UNITED STATES PATENT AND TRADEMARK OFFICE

10/699,450

Office Action Summary

DETAILED ACTION

Figure 4 of Thual is reproduced below.

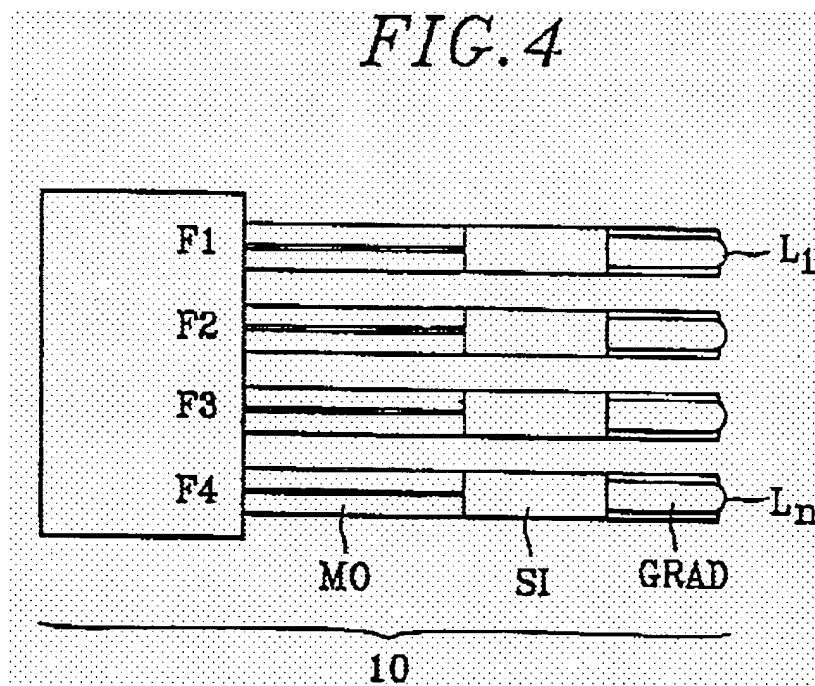
Regarding claims 1, 5, and 21, Thual discloses a fiber lens (e.g., see Figure 4), comprising:

a graded-index lens ("GRAD");

a single-mode fiber ("MO") disposed at a first end of the graded-index lens;

a refractive lens ("L₁") having a hemispherical shape formed at a second end of the graded-index lens ("GRAD") to focus a beam from the single-mode fiber to a diffraction-limited spot; and

a spacer rod ("SI") interposed between the graded-index lens ("GRAD") and the single-mode fiber ("MO").

Thus, Thual only differs from claims 1, 5, and 14, in that Thual does not teach a hyperbolic shape.

The Edwards article, however, teaches that lenses with hyperbolic shape are superior to lenses with hemispherical shape (see Abstract). Thus, modifying the hemispherical lens L_1 in Thual to have a hyperbolic shape would have been desirable in view of Edward's teachings.

Regarding claim 4, Thual specifically teaches forming the lens ("L₁") by melting an end of the graded-index lens ("GRAD") (Thual, col. 4, lines 29-32). Thus, in the Examiner's opinion, it would not have been obvious to modify Thual so that his spacer rod ("SI") is interposed between the refractive lens ("L₁") and graded-index lens ("GRAD"). Therefore claim 4 is deemed allowable.
